MSC APOLLO 13 INVESTIGATION TEAM

FINAL REPORT

CORRECTIVE ACTION STUDY
AND IMPLEMENTATION

GOVERNMENT
FURNISHED EQUIPMENT

FIGURE A2

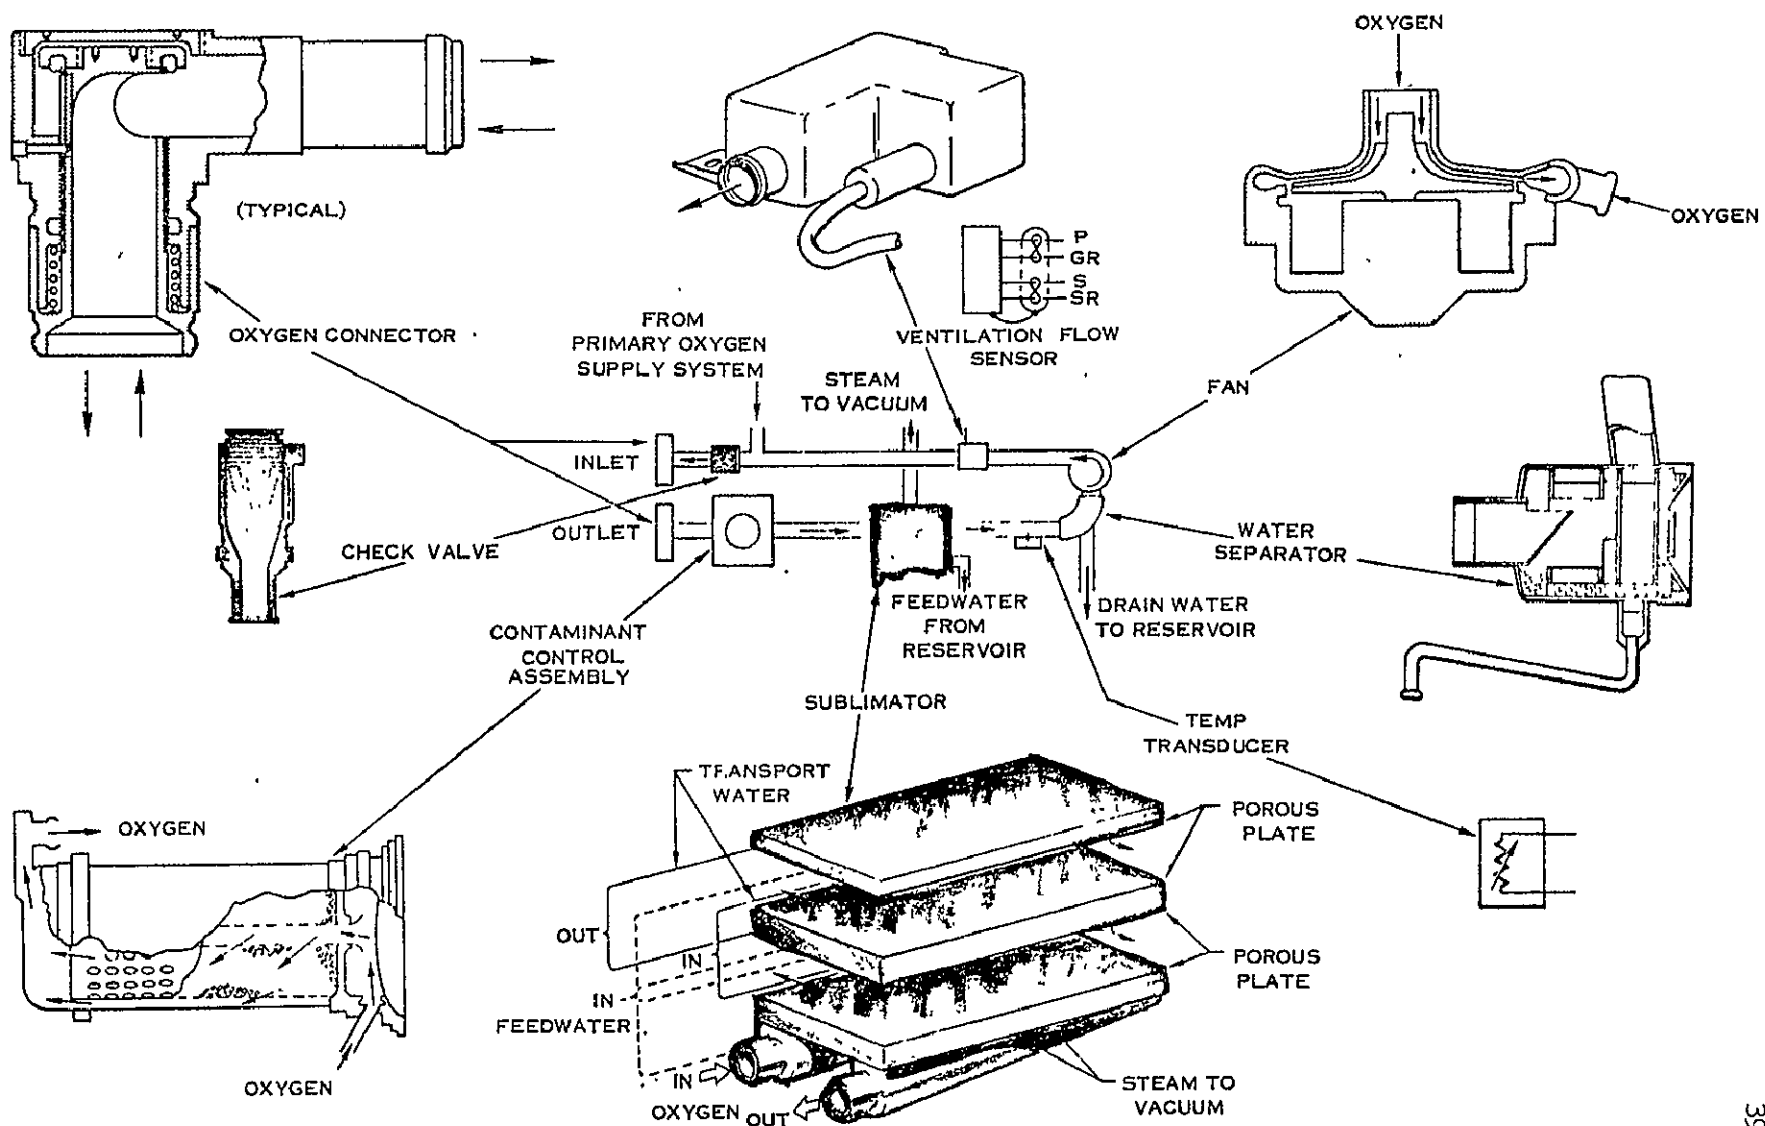
ITEM: PLSS O₂ Ventilation Circuit (see page 39)

FAILURE: Gross Leakage (8#/hour:equivalent to $\frac{1}{4}$ inch hole in suit bladder)

POSSIBLE CAUSES: Physical Damage from External Source or Structural Defect

WHY SPF PRESENT: Elimination would require redundant ventilation circuit and PGA interfaces plus complex crossover valving yielding excess weight and volume with increase in potential failure points.

Design: Umbilicals have inner pressure wall plus fabric wrap and wire reinforcing. All component connections are bonded and clamped. Seal usage reviewed for requirements. Only components exposed to external damage are PGA umbilicals which are covered with beta cloth enclosed thermal sheath which provides abrasion protection. Internal plumbing is metallic. Umbilical axial load requirements set at 60 pounds minimum.

RECOMMENDATION: No Change Required.

FIGURE A3

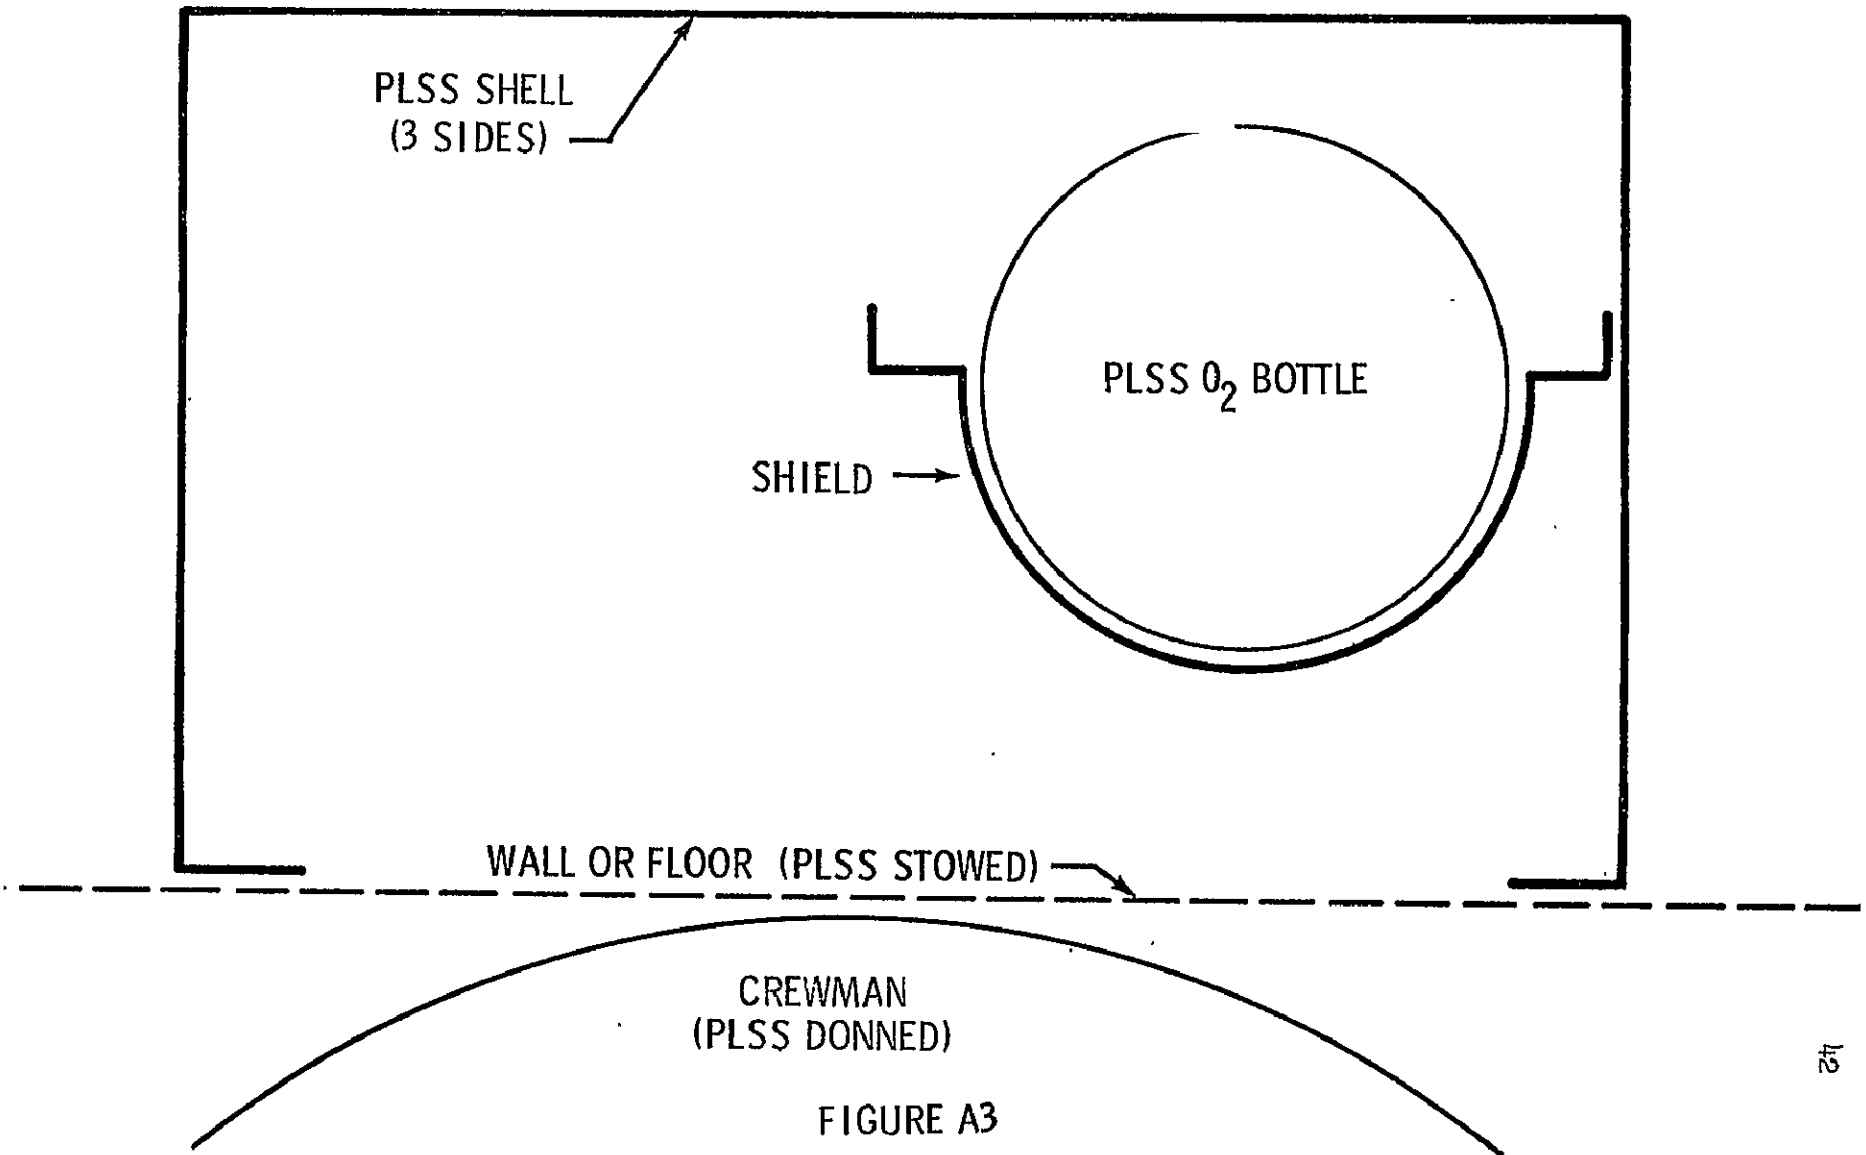
ITEM: PLSS Oxygen Bottle (See description, pages 42 - 44).

FAILURE: Rupture (Explodes)

1. No other means presently feasible for required application.
2. Incorporation of scatter shield would require excessive weight and volume.

Design: Reference Page 42 for physical data on POS bottle.
Reference Page 44 for protection of PLSS O₂ bottle from external damage.

RECOMMENDATION: No change in bottle design or plumbing.

NOTE: -7 PLSS Bottle changed to approximately 1400 psi operating pressure. Requalification test program will assure reliability retention.

FIGURE A5

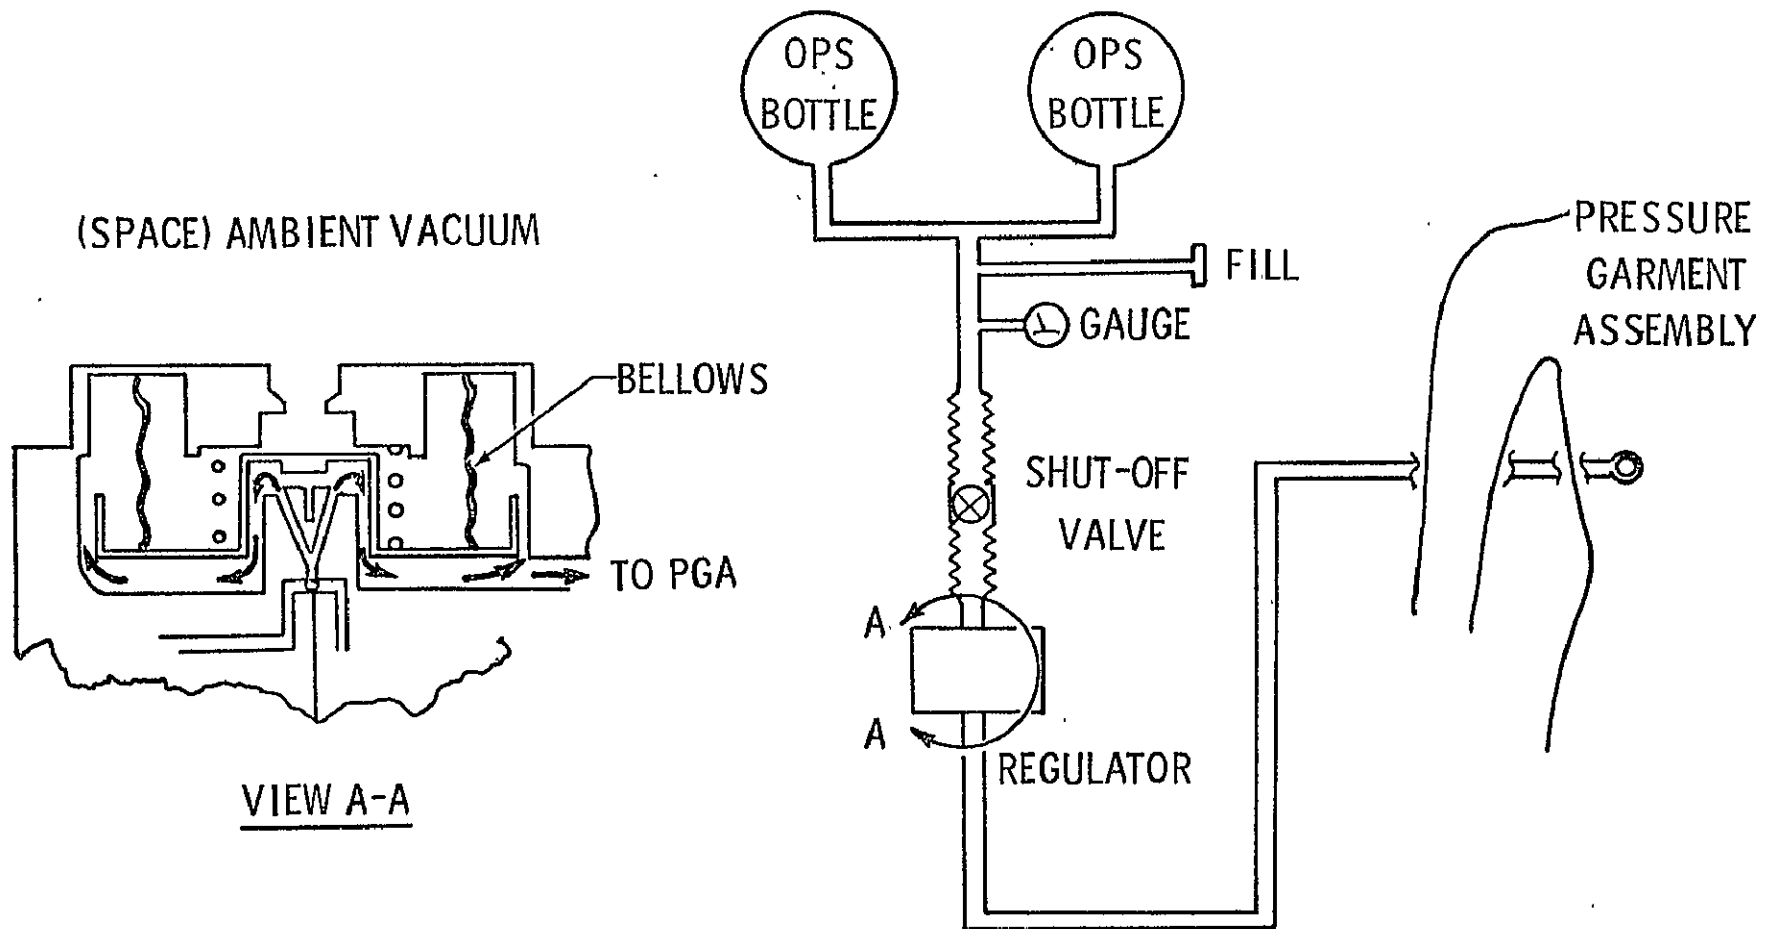
ITEM: OPS Umbilical

Design: Umbilical designed with inner pressure sealing liner protected by fabric wrap and wire reinforcing in outer layers. Umbilical also covered by beta fabric enclosed thermal sheath which provides added abrasion protection. Umbilical axial load requirement set at 60 pounds minimum.

RECOMMENDATION: No Change Required.

FIGURE A6

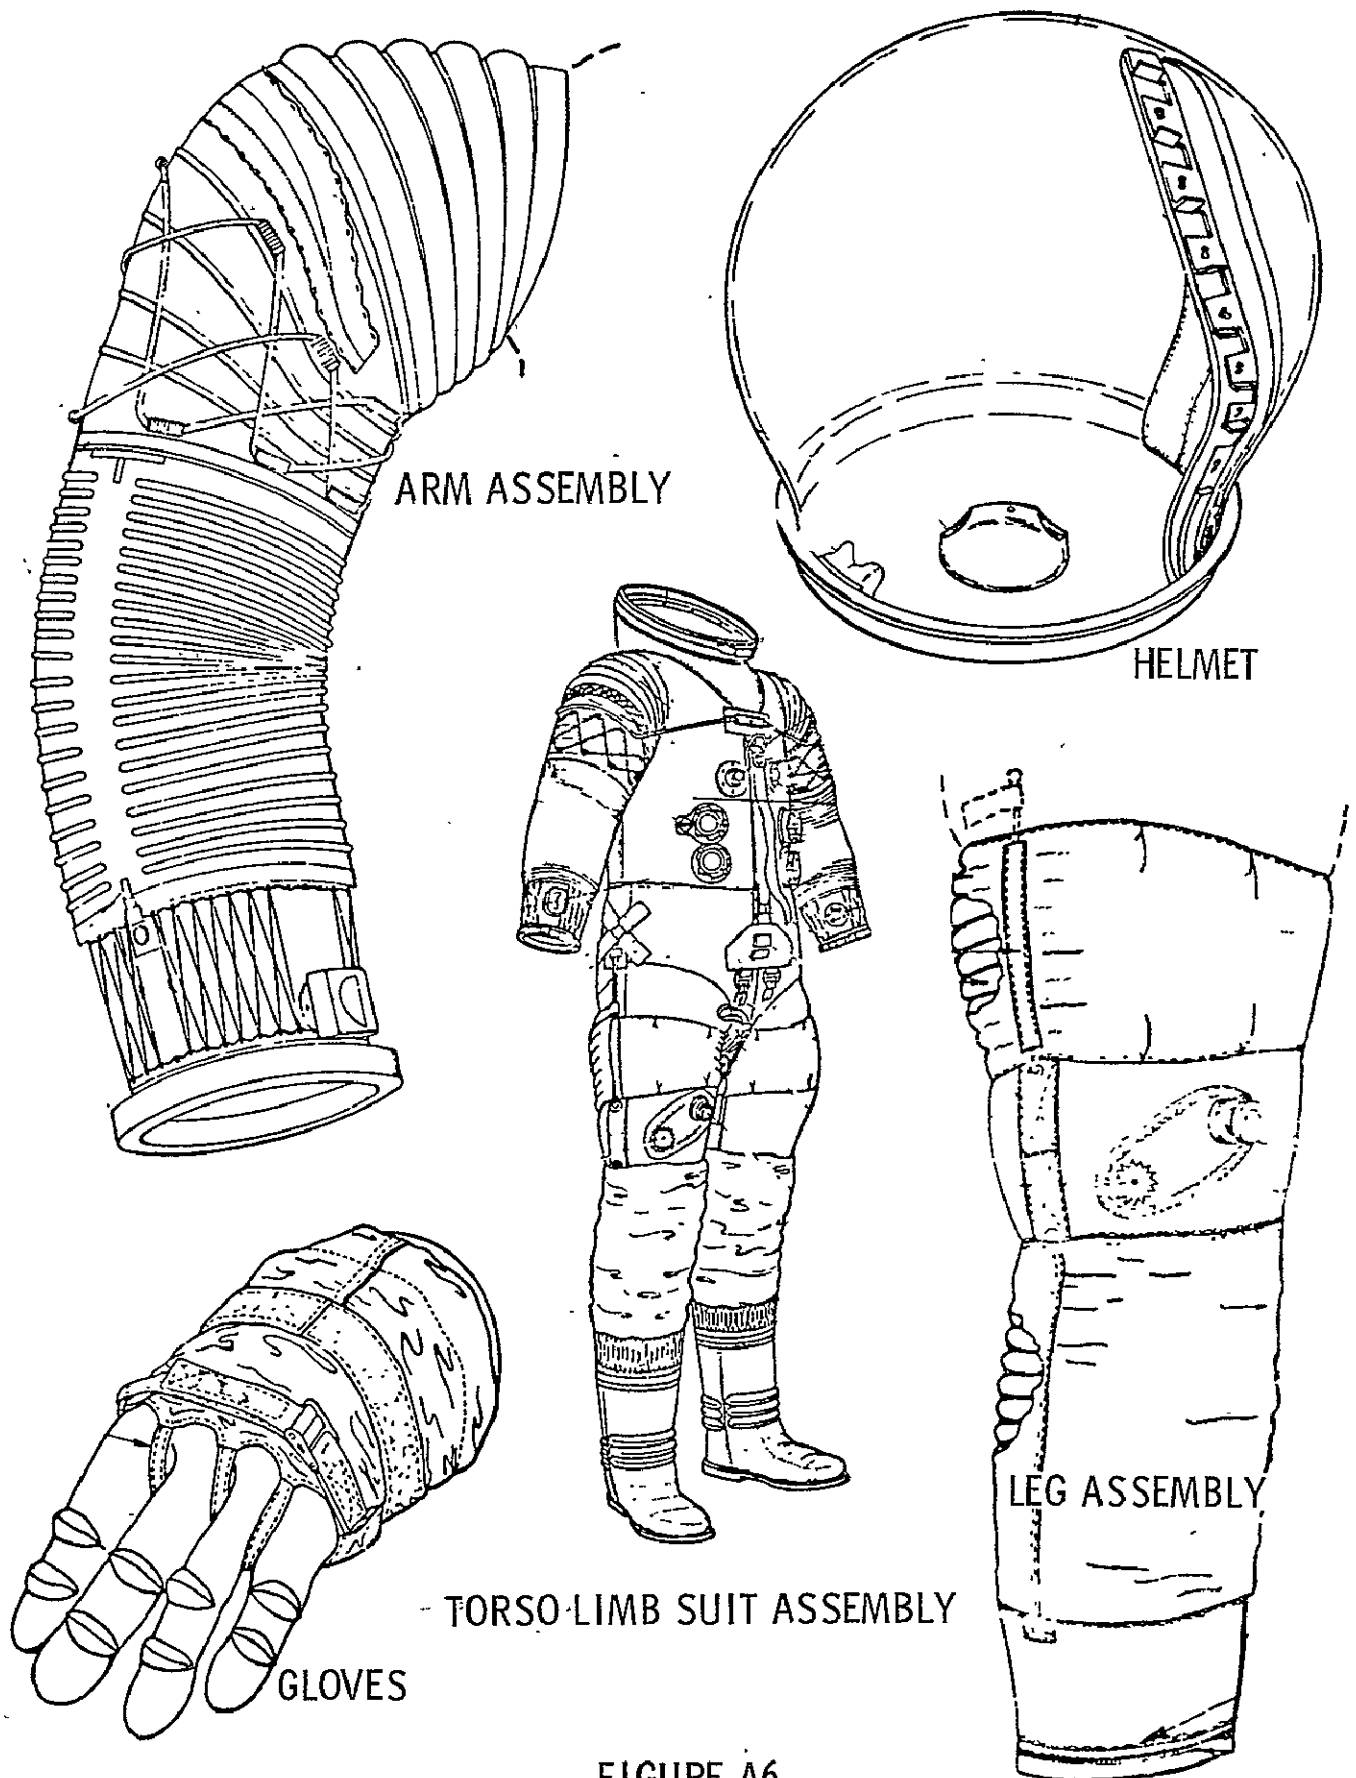
6E142 Add reinforcement patches

6E160 Add protective layer to PGA

7E133 Add abrasion cover to IV gloves

7E175 Add scuff patches to torso, limb suit assembly

05052 Add redesigned scuff patches and knee patches

FIGURE A7

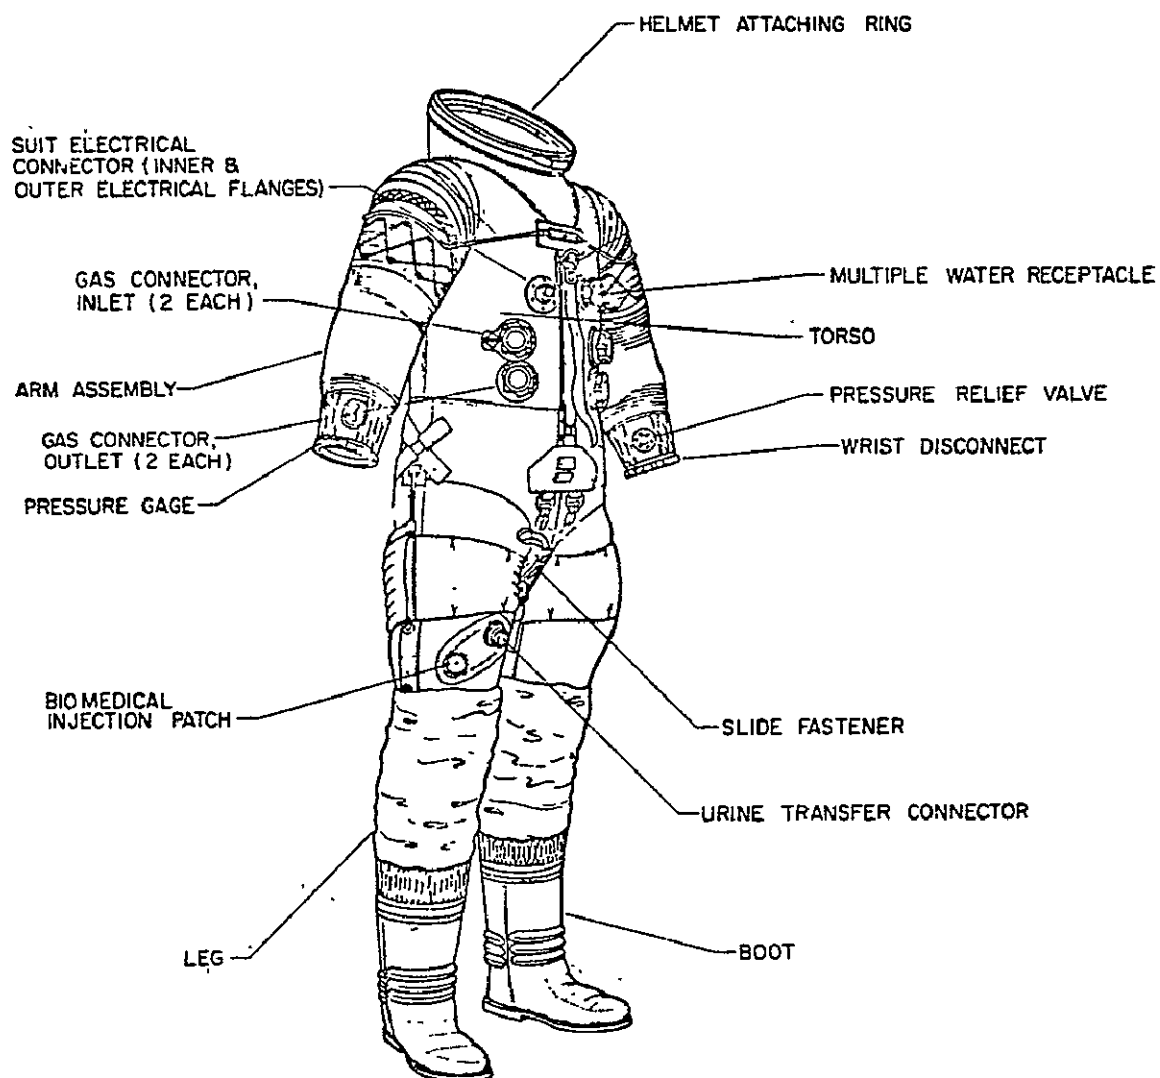
B. Catastrophic failure of a PGA pressure retention layer penetration (i.e. zipper, wrist disconnects, connectors etc.)

6E097 Change "O" ring from single to double bar

6E118 Add lock lock to glove and helmet closure

7E076 Add safety locks to gas connectors

8E109 Change pressure sealing zipper lock lock
